# 42 HONEYSUCKLE DRIVE COTTAGE CREEK PRECINCT NEWCASTLE

STATE SIGNIFICANT DEVELOPMENT (SSD-10378)  
DEVELOPMENT MODIFICATION 2

ARCHITECTURAL DESIGN STATEMENT

NOVEMBER 2021

# 0.1 DESIGN CHANGES GROUND FLOOR

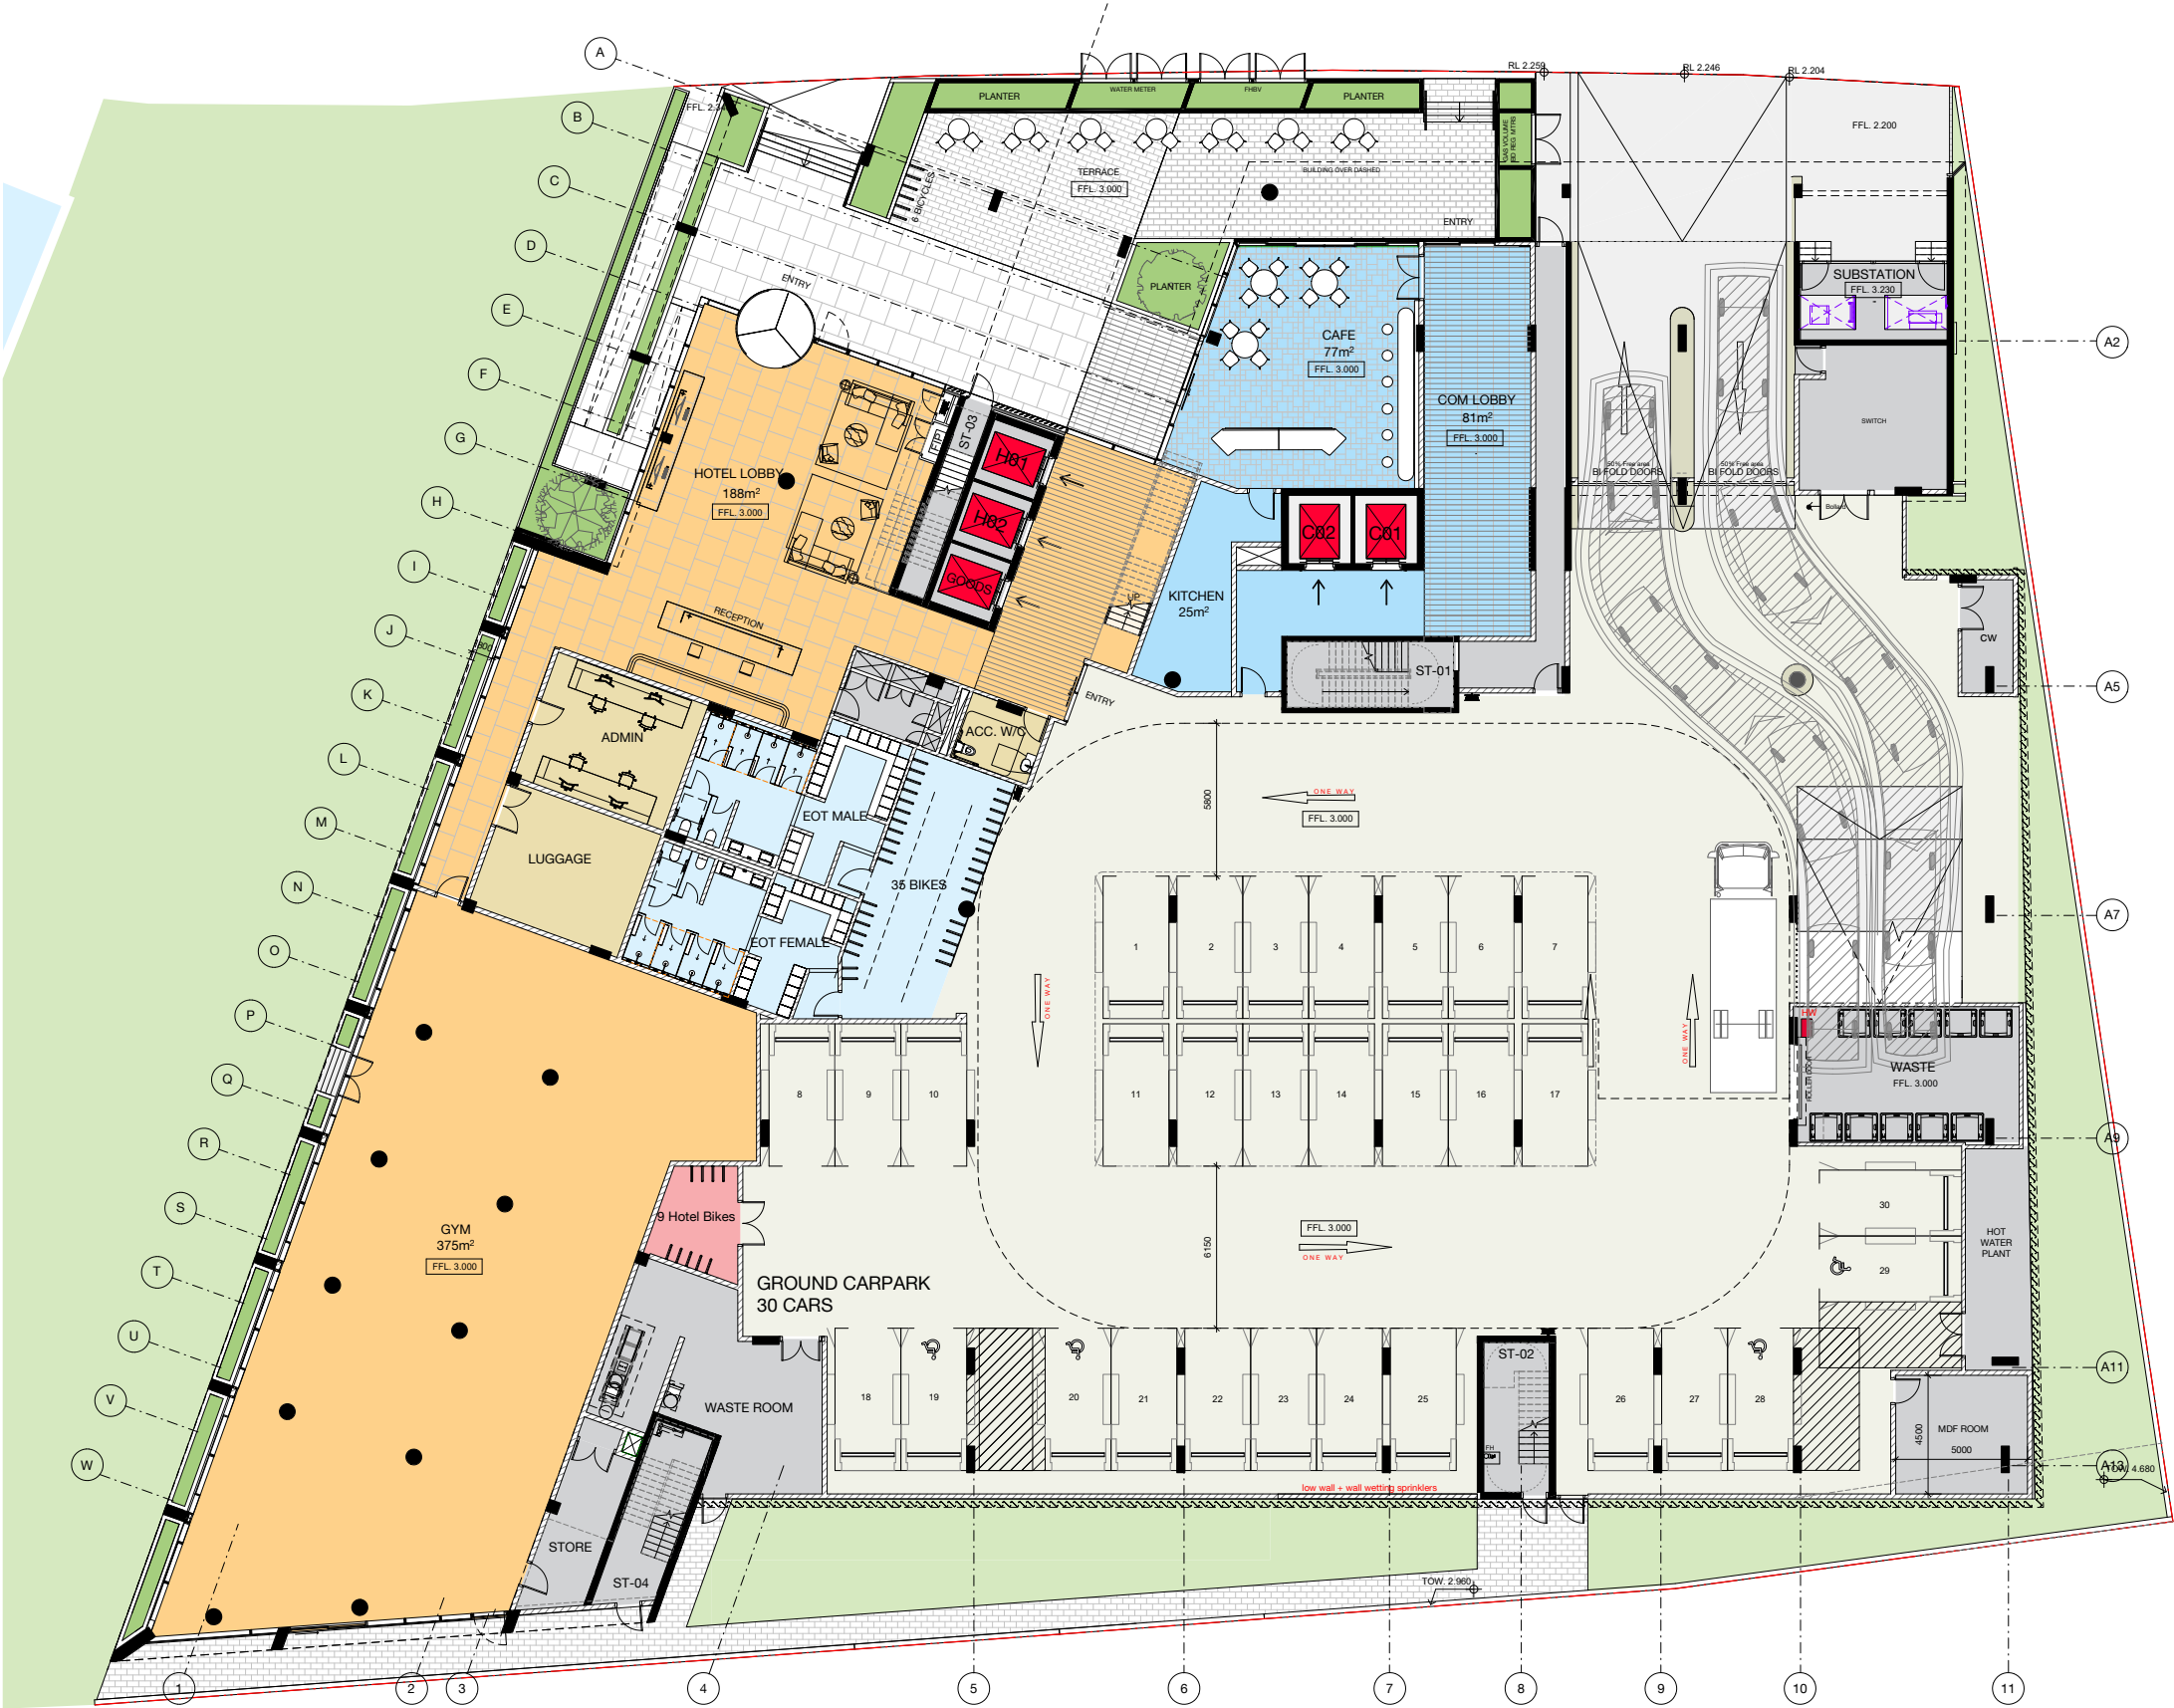
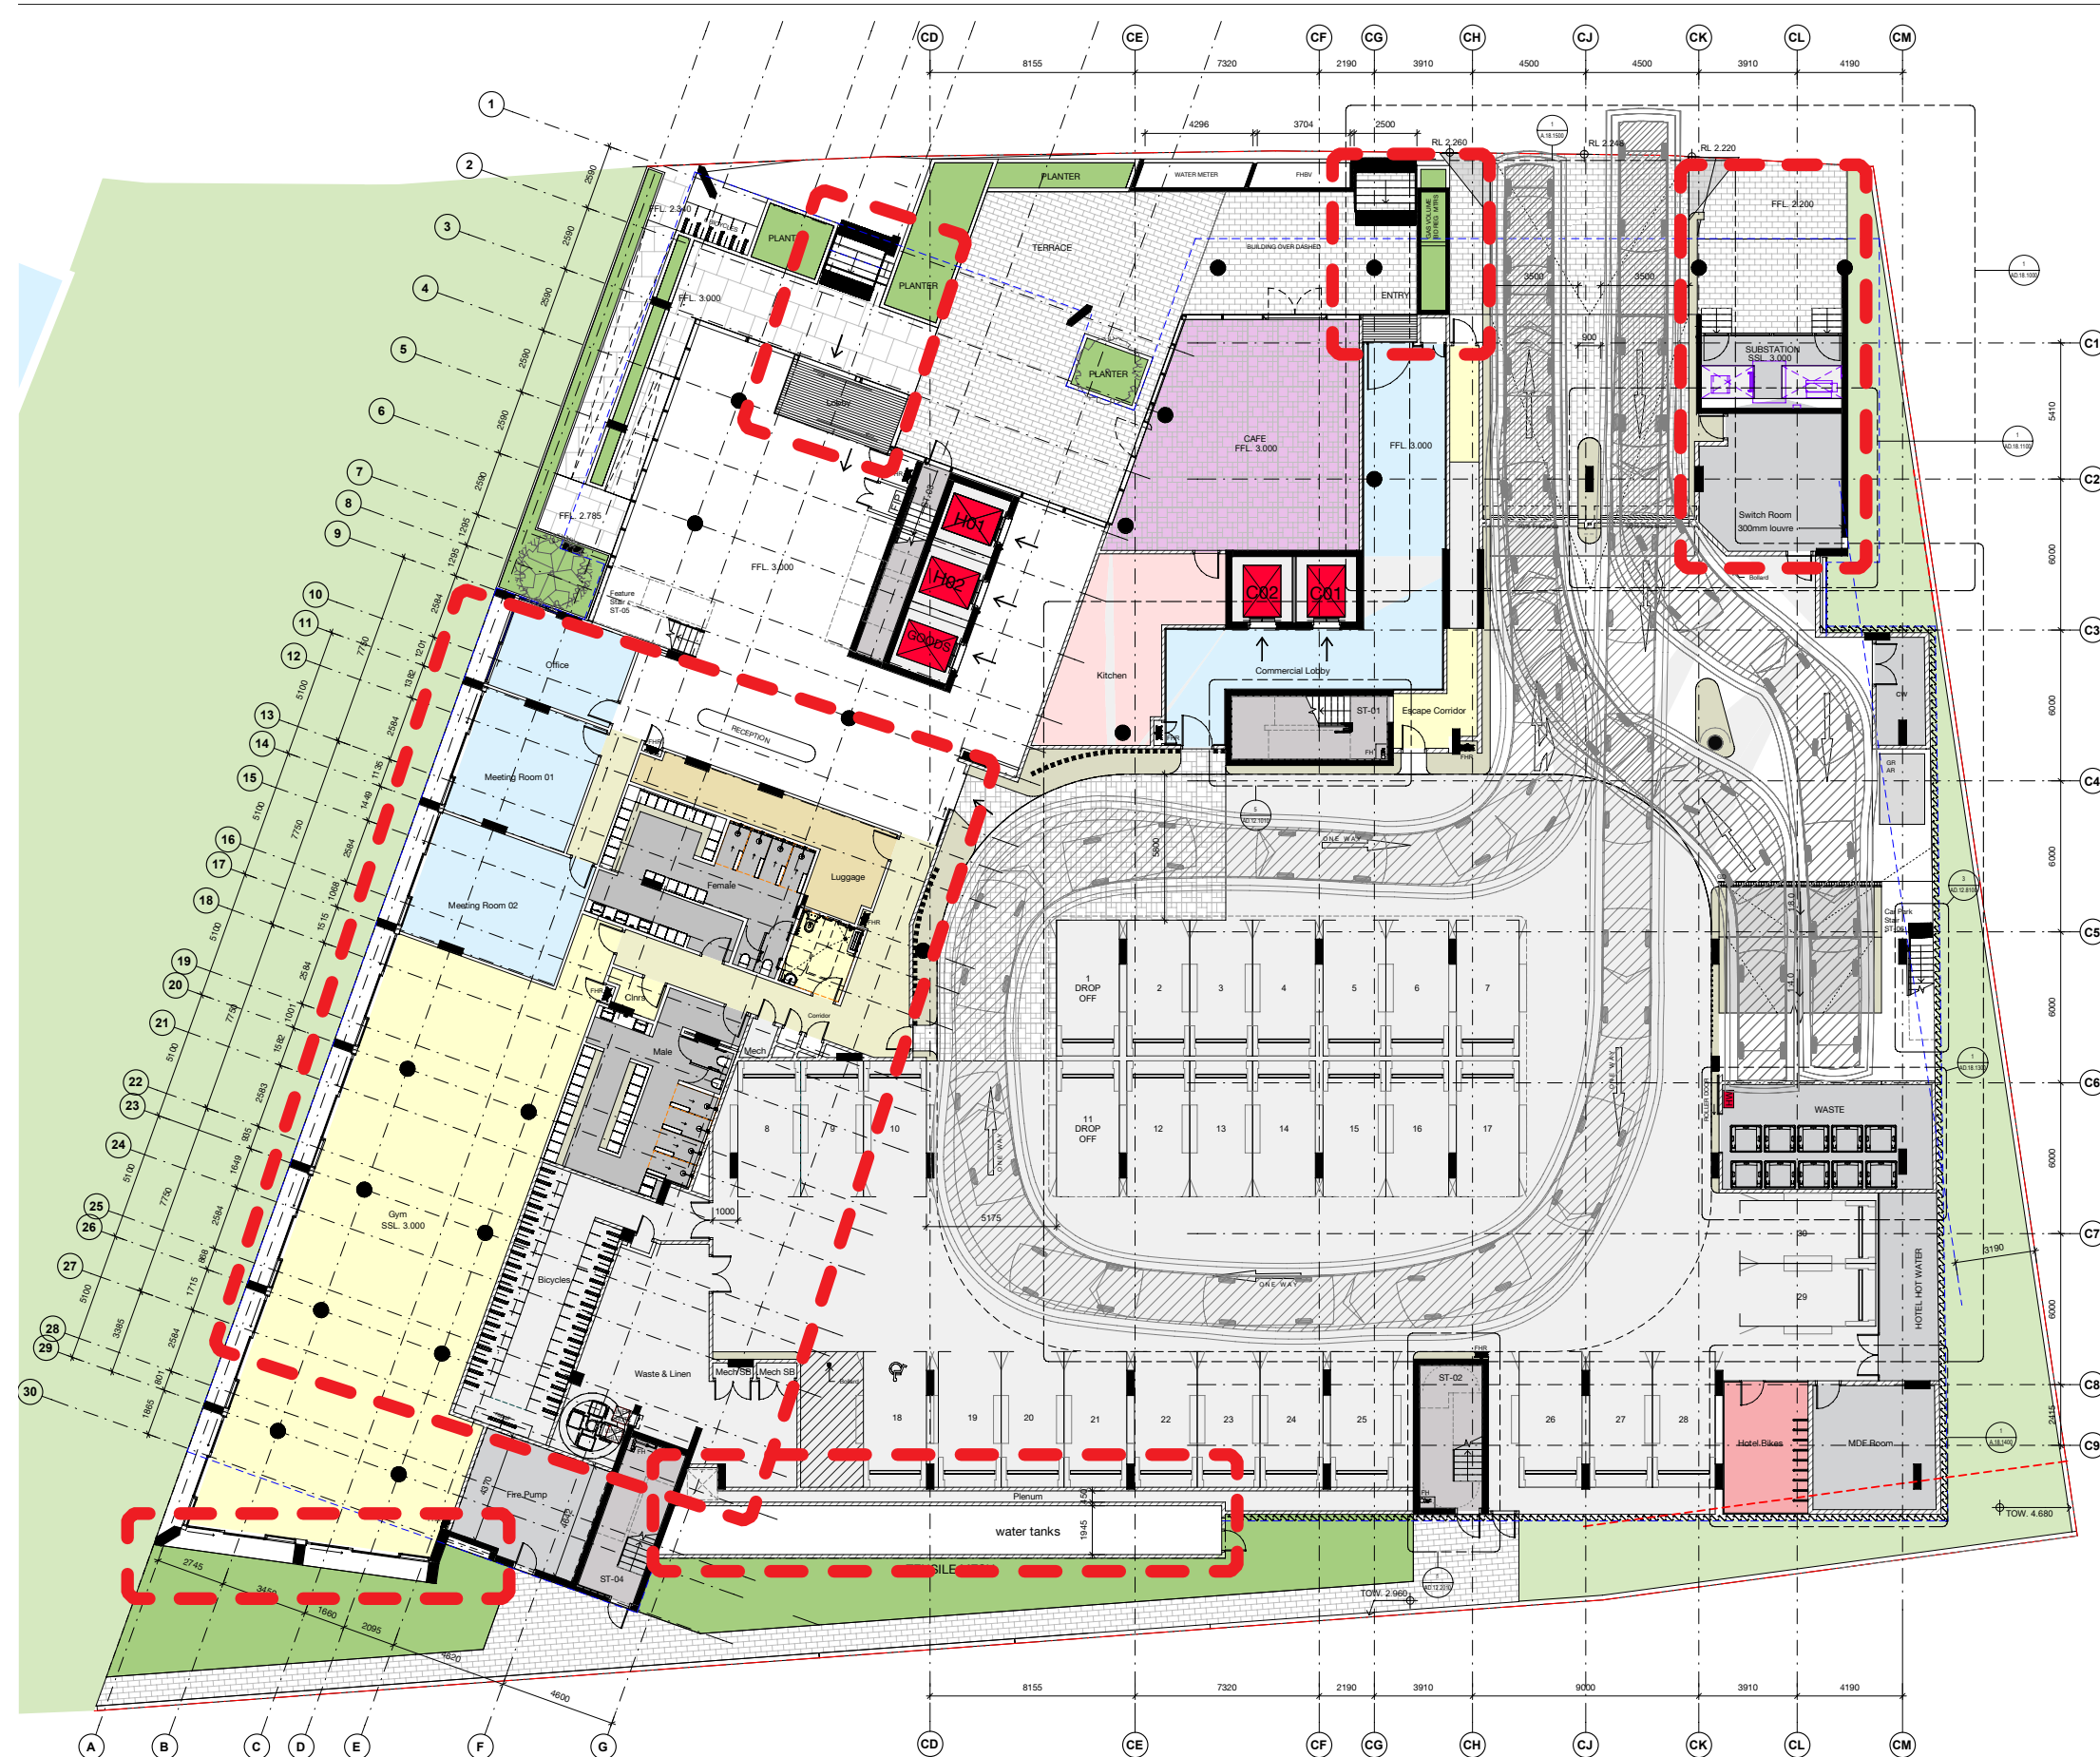
1 / South west end of the building at levels L00/L01/L02 set back from south boundary line.

2/ End of trip facility/ meeting rooms/ BOH configuration amended to accommodate a deeper reception space and visibility to carpark/ entry and lift lobby.

3 / Hotel entry location shifted including external stair access.

4 / Substation location shifted 450mm to the west to align with structural columns above.

5 / Commercial entry and location of stair access shifted 450mm to the west.

6 / Fire tank projection to the south face of the building at 1 storey high
